TPS2384 Power Sourcing Equipment Power Manager Device Errata

Figure 2. TPS2384 Rev. 01 Auto-Mode Sequence Flow Diagram

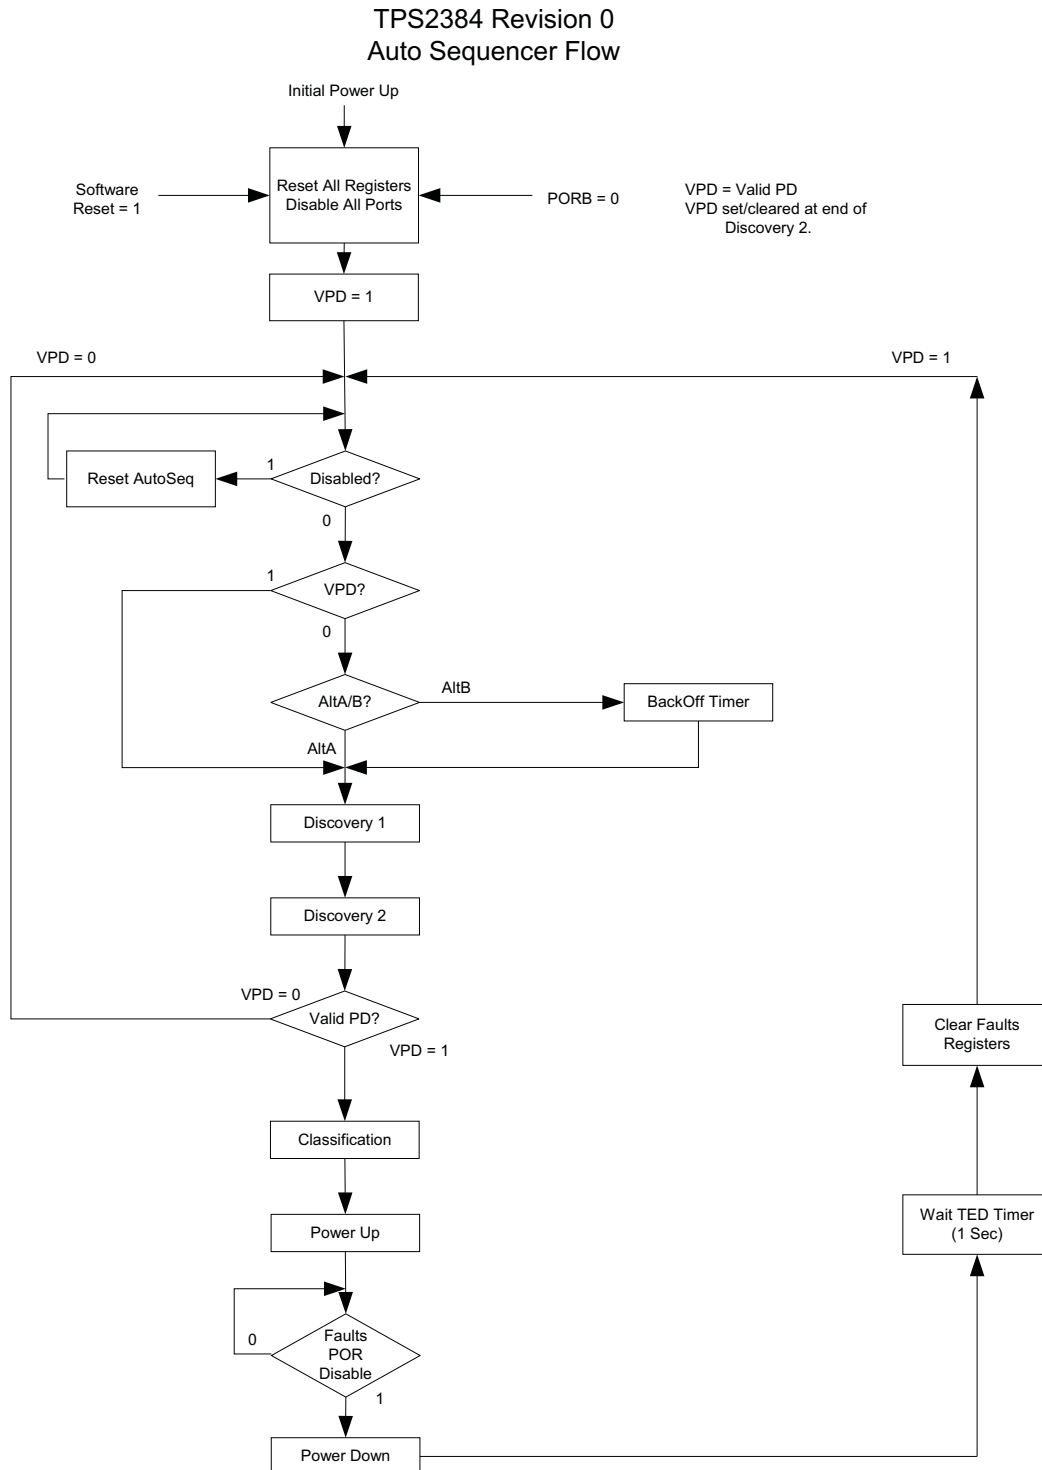
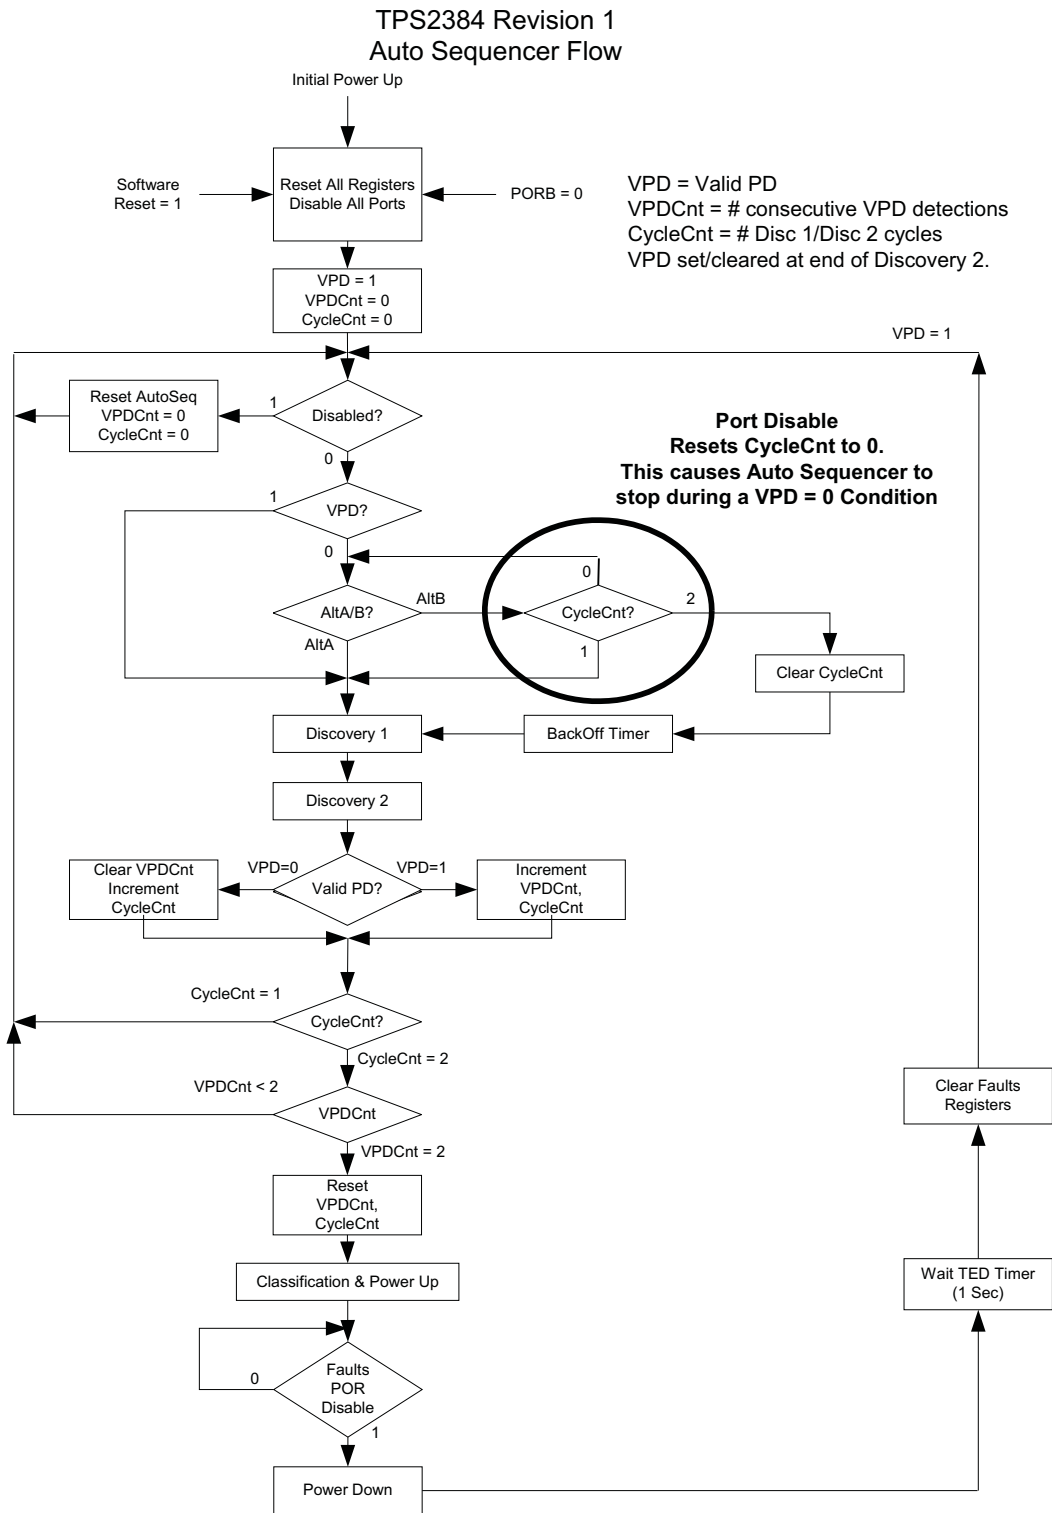
In creating the revision 01 device from the original version, new logic circuits were added, and existing gate interconnect modified, to change the device AM detection function from a 2-point Discovery to a 4-point Discovery scheme. The original circuitry correctly handled the three possible outcomes of port sequencing which return function flow to the start of the Discovery/Classify/Power sequence:

The change to the new 4-point Discovery algorithm required additional logic to control launching the internal Back-off Timer, and resumption of Discovery after back-off expiration. These design changes inadvertently generated a logic error such that it no longer correctly handles return to start in Alternative B with an invalid PD result (condition 3 above).

Refer to the diagrams in [Figure 1](#) and [Figure 2](#) below for a graphical representation of the circuit differences between revision 00 and revision 01 devices.

Figure 3. Semi-auto mode/Alternative B schematic for active ALT_A/B control.

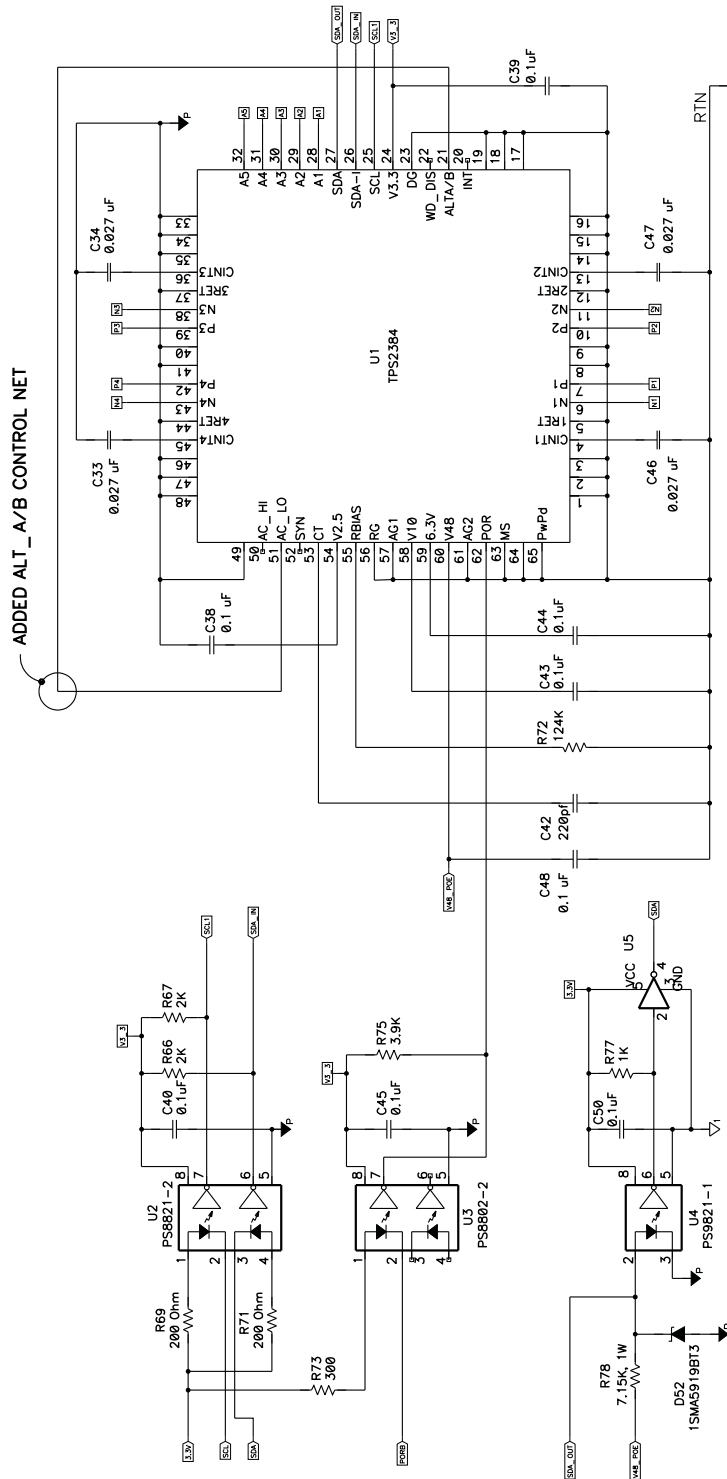
TI has discovered that a port hung as described above can be returned to normal operation without the use of a full device reset. Upon re-enable, if the ALT_A/B pin is momentarily toggled low and then high again, the device channel will recover and resume Discovery 1/Discovery 2 probing. This requires that semi-auto applications do not connect ALT_A/B directly to a supply rail (e.g., the device V3.3 pin or other logic supply), but rather connect it to some binary, logic-level drive, with at most a resistive pull-up to the local logic rail (depending on drive configuration).

For ensured operation of the port recovery mechanism, the low-going pulses at the ALT_A/B input must have a minimum pulse width of 10 μ s.

Figure 3 shows the typical auto-mode schematic modified to incorporate the suggested fix. Note that the AC_LO pin is connected directly to drive the ALT_A/B pin. The logic-level drive circuitry of the AC_LO output is used to toggle the ALT_A/B input, according to the requirements above, via commands over the I²C bus.

The reset state of the AC_LO output is a logic 0, setting the pin state to a logic low voltage. As soon as practical in the initialization sequence after I²C POR, the controlling firmware should set AC_LO high by writing a logic 1 to bit D3 of the Common Control Write register (Register Select address = 0001b). This operation configures the TPS2384 device for Alternative B mode. Refer to the device data sheet for details on POR timing. Alternative B applications may want to add POR pin control from an available host I/O pin as shown in Figure 3, to facilitate this PSE initialization.

- a. Write the Port Enable bit D4 of Port Control register 2 (Register Select address = 0011b) to a logic 0 (enabled).
- b. Write the AC_LO bit D3 of Common Control Write register (Register Select address = 0001b) to a logic 0.
- c. Write the AC_LO bit D3 of Common Control Write register (Register Select address = 0001b) to a logic 1.
